TECHNICAL NOTE

(Doc Ref: 1368-WSP-00-XX-RP-CV-0002)

DATE:	09 June 2021	CONFIDENTIALITY:	Restricted
SUBJECT:	Alternative highway and drainage options for Roxton Road link (north)		
PROJECT:	70061368 – Dove House Farm, Wyboston	AUTHOR:	Anthony Groom / Joe Leslie
CHECKED:	Livio Martelli	APPROVED:	Livio Martelli

This technical note has been prepared to assist our clients, Duncan & Maxine Buchanan, of Dove House Farm, The Lane, Wyboston, with making a formal representation to the Planning Inspectorate (PINS) in relation to the following elements of Highways England's A428 Black Cat to Caxton Gibbet proposed highway improvement scheme (the Scheme) that would directly impact on their property:

Table 1 Areas of land acquisition

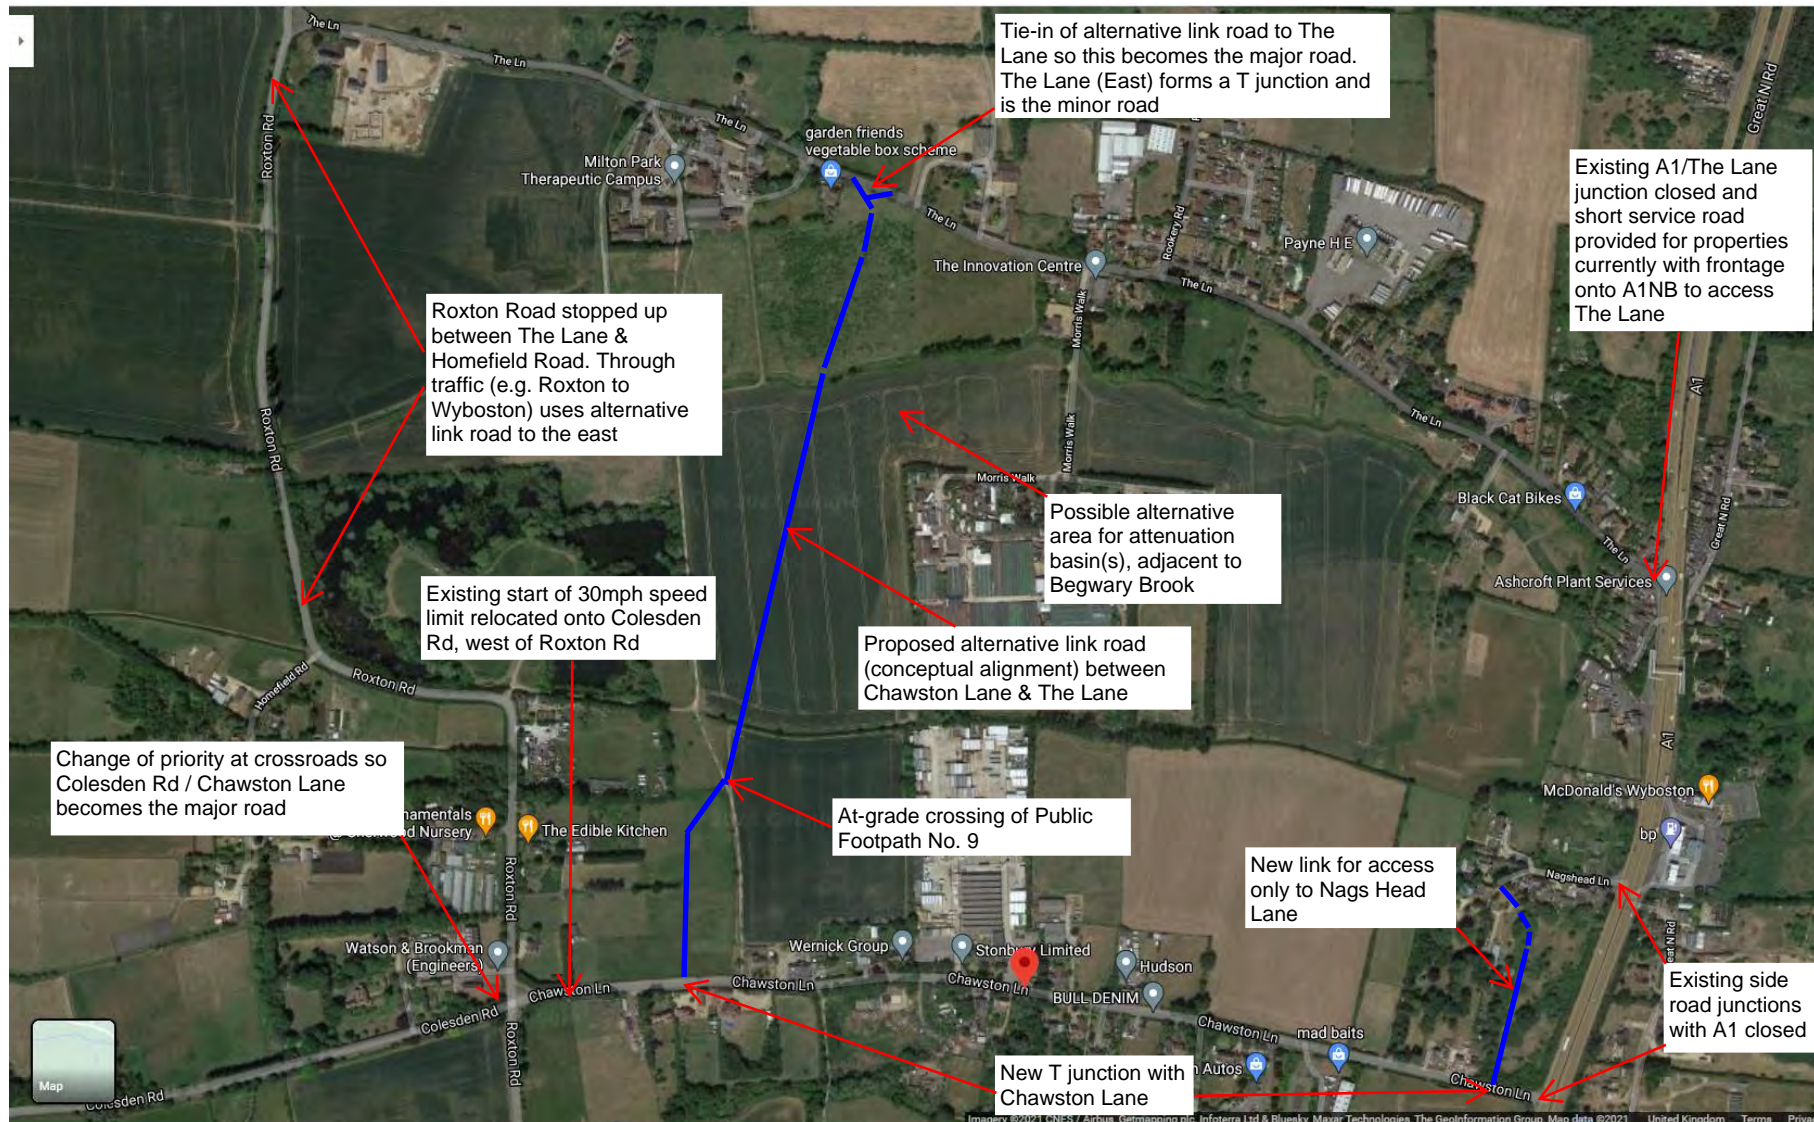
- 1.1.8 The WSP technical note suggests an alternative design for the horizontal alignment at the location of the double bend. This uses a 70m stopping sight distance and horizontal radii of 54m and 100m at the double bends. It states that this allows for more flexibility around the central section of the scheme without compromising forward visibility, swept path analysis or safety.

- 1.1.9 Whilst the use of the 54m radius bend may have a greater speed control effect on vehicles, it is applied over a shorter distance than the equivalent 64m radius used in the scheme design (approximately 56m compared to 77m) so may not have a sustained effect. The suggested use of the 100m radius would reduce the speed control effect when compared to the 64m radius used in the scheme design. The forward visibility along this section is also greater (it was measured from the PDF drawing provided as approximately 85m). Whilst the difference in speed control between the scheme design and WSP suggestion is likely to be marginal, MfS2 Cl. 8.3.8 and MfS1 7.4.4 imply both of these changes could either individually or in combination encourage higher speeds along the section from Chawston Lane to the first bend.

- 1.1.10 The 100m radius bend also starts closer to Chawston Lane and would result in the removal of approximately 30m of established hedge that would provide visual and noise screening between the new road and the residential properties on Nags Head Lane. It also brings the road closer to these properties. The new road in the scheme design is approximately 120m from the properties but this would reduce to 100m. The loss of part of the hedge would also result in a modest loss of habitat.

- 1.1.11 Other aspects of the design (carriageway/verges/footpaths width, kerb radii, 2m widening on curves, buffer zone width) are stated to have been replicated. This is not the case for the widening on the 54m radius bend, which measures (from the PDF copy available) as 7m. This would cause safety issues for two HGVs trying to pass one another. The extent of the earthworks replicates the original design, which is not an unreasonable assumption, but it does not fully do this through the realigned section and the overall extent of the earthworks and verge is approximately 1m narrower than shown for the original design.

- 1.1.12 It is stated that the attenuation basins associated with the road have been reshaped to increase their land usage efficiency. The overall area of each pond is stated as being retained to ensure their capacity. The areas of the two ponds in the scheme design, including the maintenance access berm around each is 1040m² and 1495m² (north and south of the Nagshead Lane access respectively). The reshaped ponds measure as 1048m² and 2287m². The smaller pond is obviously intended to be the same area and the small difference in areas is negligible. The reason for the increase in area of the larger pond is not clear. A small landscape planting area has been retained.

1.1.18 In summary, comparing the two designs;

- The two designs will both provide speed control at the double bend.
- MfS2 clause 8.3.8 and MfS1 clause 7.4.4 imply that the alternative design would not provide as much speed control as the scheme design, firstly because the first bend uses a larger radius and secondly the forward visibility around both bends is greater than required by standards. The impact of the shorter application of the tighter radius is probably marginal.

- The alternative design moves the road closer to existing residential properties.
- The alternative design requires the removal of at least 25m of existing hedge that provides a noise and visual screen to properties on Nags Head Lane.

- The alternative design does not reduce the area of land that Highways England would need to acquire permanently. It does reduce permanent land acquisition at Dove Farm, but requires permanent acquisition of land elsewhere to mitigate.

DRAINAGE ENGINEERING PLAN

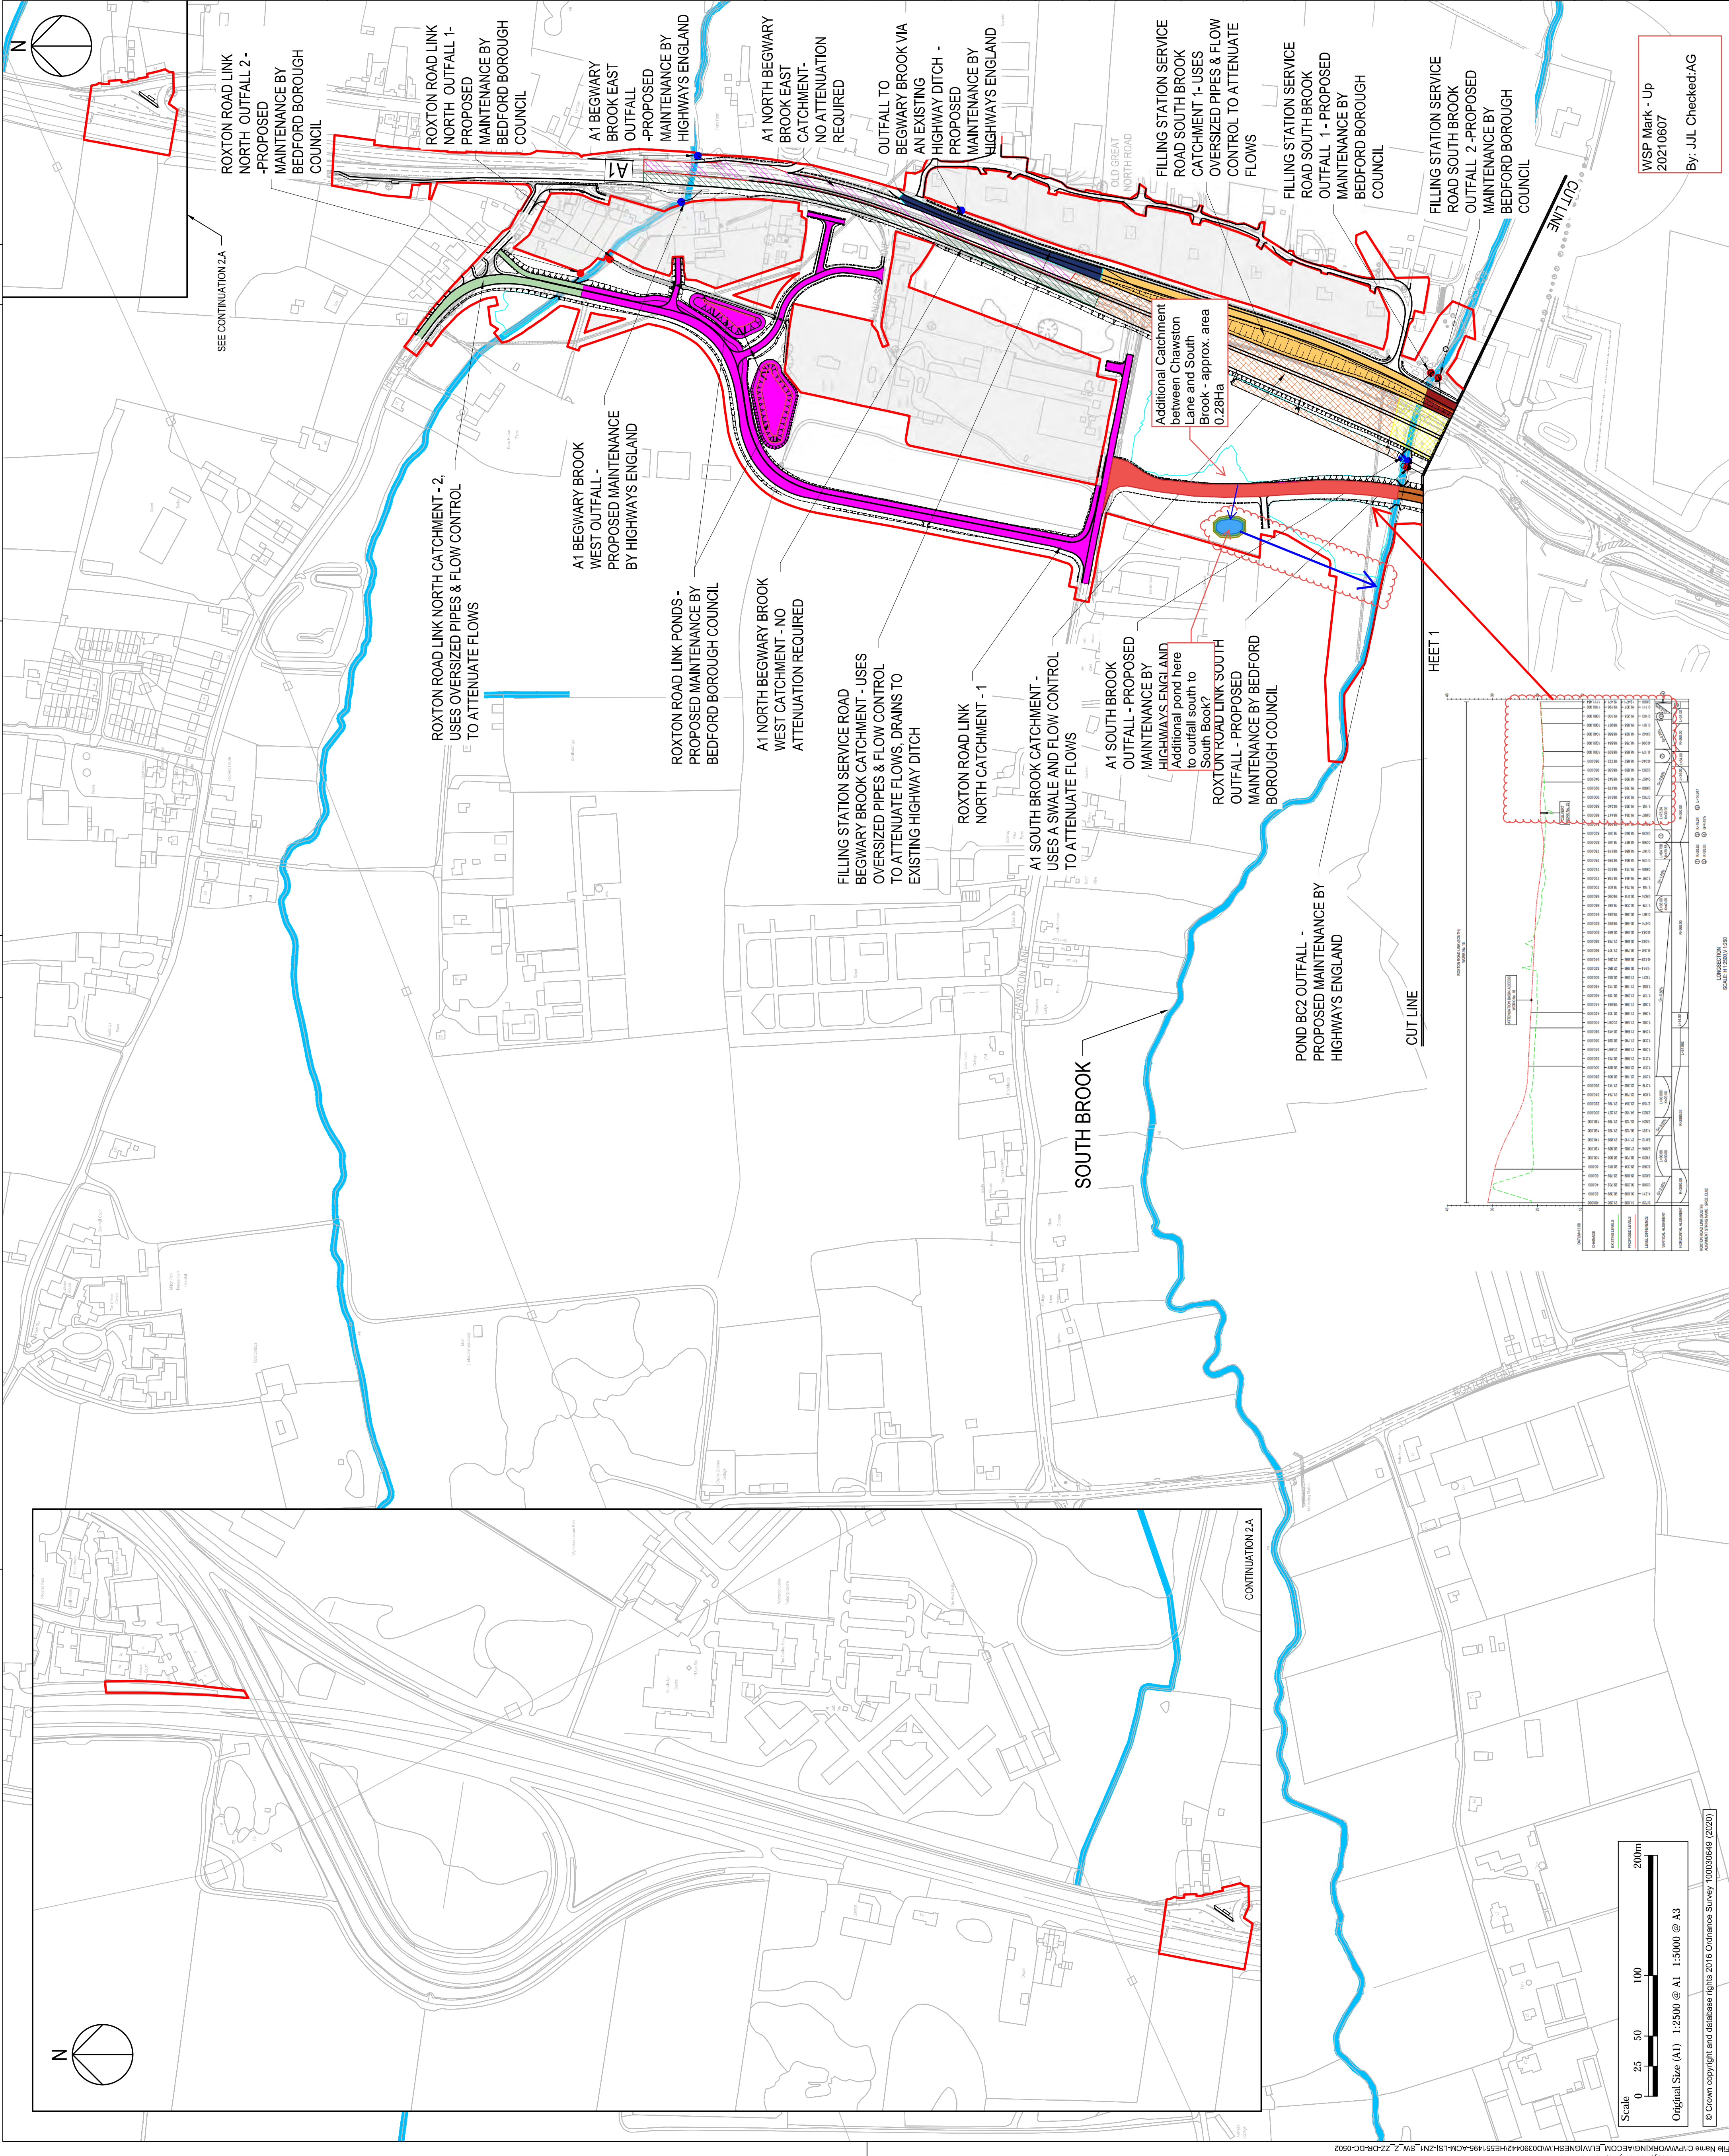
The location of the two ponds within the catchment would appear to be appropriate based on the Roxton Link Road (North) - Work No. 29a long-section found on plan HE551495-ACM-LSI-ZN1_SW_Z_ZZ-DR-DC-2418, as they are located at a low point of the proposed road catchment. However, on examination of the long-section, Roxton Road Link (South) – Work No.18 on plan HE551495-ACM-LSI-ZN1_SW_Z_ZZ-DR-DC-2417, a further sag/low point at approximate chainage 990m is noted which has prompted us to investigate an alternative outline drainage design (see plan at Appendix C). The main features of this alternative design would involve removing the impermeable area south of Chawston Lane (shaded red on Appendix C plan) from the current catchment 1 and providing an additional pond west of Roxton Road link (south), adjacent to the above low point and within the current order limits, to attenuate flows from the additional catchment area before discharging into South Brook. The size of this additional pond has been calculated as follows:

- South of Chawston Road the catchment comprises approx. 0.28ha of impermeable area. Based on a source control storage estimate utilising FSR data in Microdrainage and an assumed discharge rate of approx. 0.6 litres/sec (from the HR Wallingford Greenfield estimation tool), a storage requirement of 220m³ would be required in a 1 in 100 + 40% climate change allowance storm event.
- At a depth of 1.5m (including a 300mm freeboard) and 1 in 3 side slopes a pond of top area of 335m² would appear to be sufficient for this additional pond.

- iii) Referring to the Microdrainage output in Appendix D, the calculations undertaken are considered to be a conservative approach and the sizing could be reduced if further design detail was provided by HE.

Can HE please clarify why an alternative drainage design, as illustrated on the plan included in Appendix C, has not been considered and why their proposed drainage design for Roxton Road link (north) is the most appropriate?

It is anticipated that this alternative design would enable the size and associated land-take of Ponds 1 & 2 to be reduced and could enable the proposed alignment of Roxton Road link (north) to be amended such that the impact on our client's land would be reduced and land-take from other landowners identified in the HE Technical Note in Appendix A could be reduced.

Furthermore, it is also not clear from the drainage strategy report which rainfall data has been used for the sizing of Ponds 1 & 2 or whether they are based on greenfield discharge limits or 5 litres/sec to prevent blockage as stated (or if this is a recommendation for future work). *Can HE please clarify the position in this regard so that further investigation of the size of Ponds 1 & 2 can be undertaken?*
